CHANGE ORDER NUMBER: 2

Project:	<u>1604-068</u>
Roadway:	<u>Forest North Drainage Ph 1</u>
CSJ Number:

**Forest North  
Williamson County Project No. 1604-068**

**Change Order No. 2**

BRAEBURN\_ZONE -  
OVERALL  
FOREST NORTH UTILITY RELOCATIONS  
AUSTIN, TX

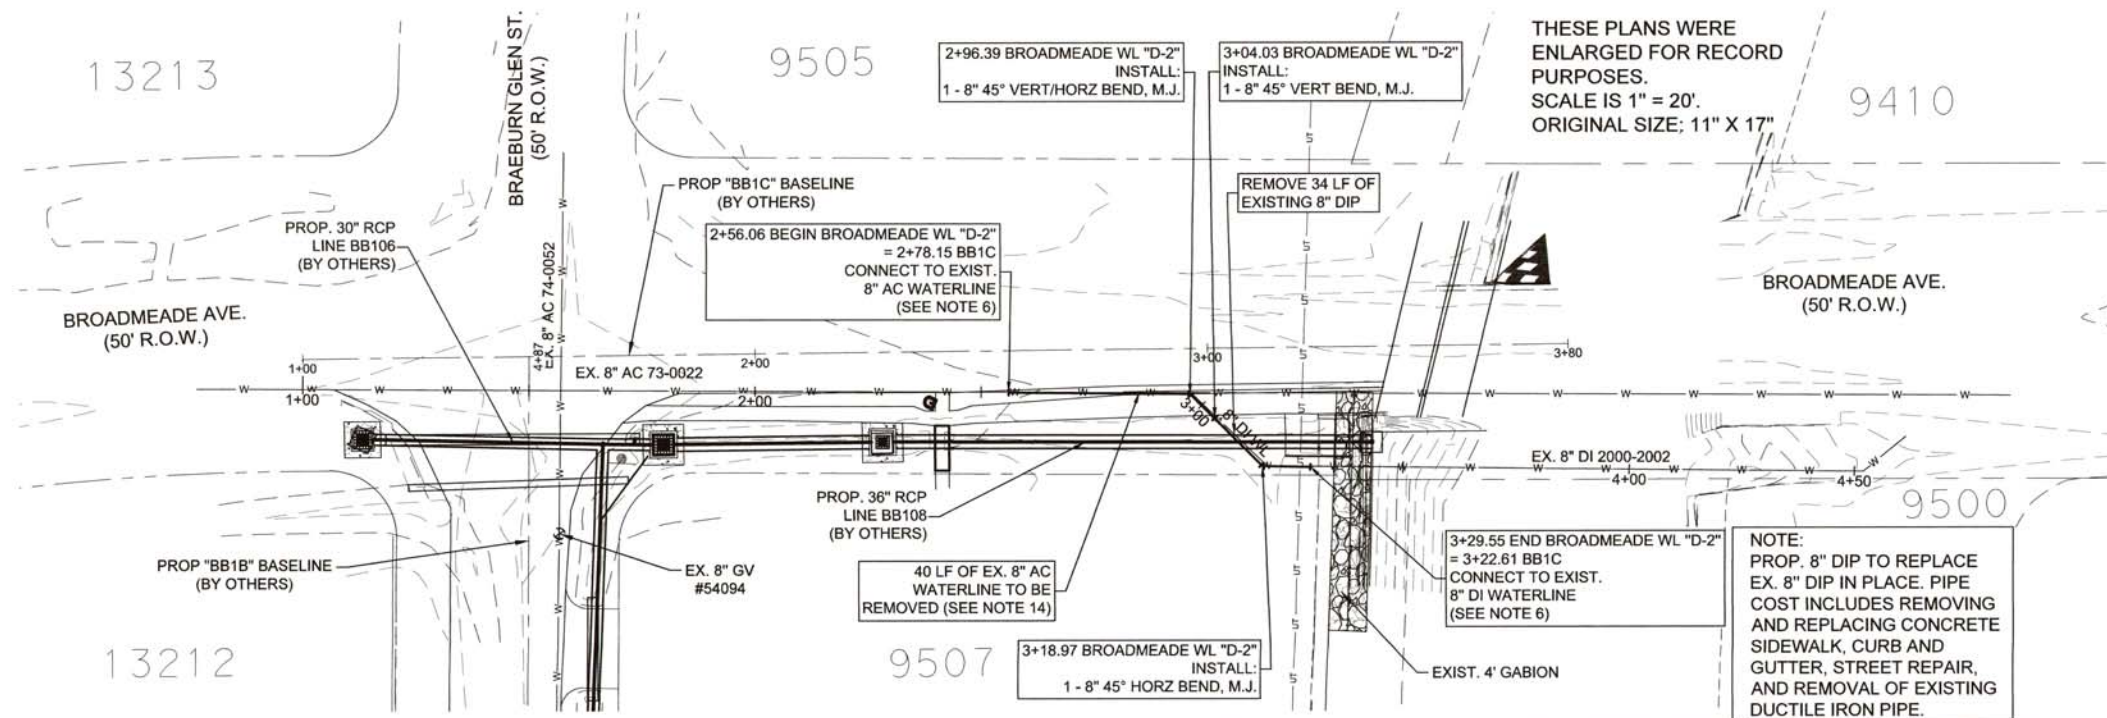
**2G: Differing Site Conditions (unforeseeable). Unadjusted utility (unforeseeable).** This Change Order compensates the Contractor for the removal and relocation of an existing waterline that is in conflict with the proposed storm sewer line BB1 at the corner of Broadmeade Avenue and Braeburn Glen. **4B: Third Party Accommodation. Third party requested work.** This change order also compensates the Contractor for completed trench repair of the asbestos line that is being removed. A portion of the trench repair quantity has been added to this change order. The remaining quantity will be added to a future change order. The City of Austin has agreed to compensate the Contractor for these costs.

This Change Order compensates the Contractor to remove and relocate an existing waterline that is in conflict with proposed storm sewer line BB1. The conflict is located near the corner of Broadmeade Avenue and Braeburn Glen. The existing waterline was not shown on the City of Austin waterline plans and therefore was not located by the One-Call services, prior to the storm sewer installation. The Contractor has agreed to extend existing bid items to pay for this work and has requested additional pay items with daily rates for de-watering the trench and required traffic control.

6. Work to be performed in accordance with Items: See attached.
7. New or revised plan sheet(s) are attached and numbered: C-114, C-122A
8. New Special Provisions/Specifications to the contract are attached: ☐ Yes ☒ No
9. New Special Provisions to Item N/A No. N/A, Special Specification Item N/A are attached.
